MEMORANDUM

To: City of Bayonne Zoning Board of Adjustment

Re: **Temple Beth AM**
Conditional Use Variance and Minor Subdivision
Block 91, Lot 11
105-119 Avenue B
R-2, Detached/Attached Residential District

Date: September 11, 2023

Exhibit 1. Property Lines on the Subject Site.

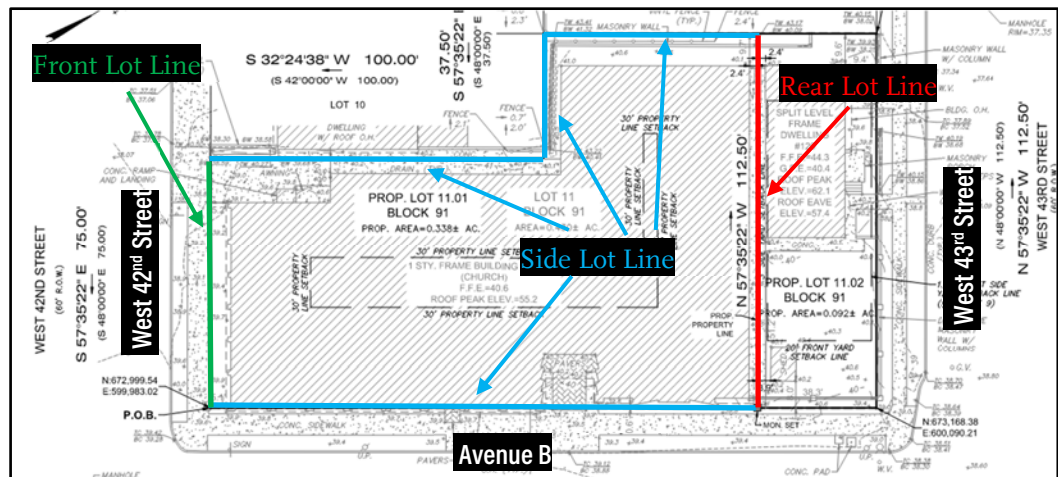
- 3.3. **Lot Line Designation for Proposed Lot 11.01.** As proposed, Lot 11.01 is shaped like a blocky “L”. This office has prepared the exhibit below to explain how the Municipal Code defines the property lines and consequently the yards applying to the site. The Municipal Code defines a front lot line for a corner lot as the shorter of the lot lines fronting on a street. The front lot line (indicated in green) is on West 42nd Street. A rear lot line is the line opposite the front property line (indicated in red) where the proposed subdivision line is located and all other lot lines that are not the front or rear lot line are considered side lot lines (indicated in blue).
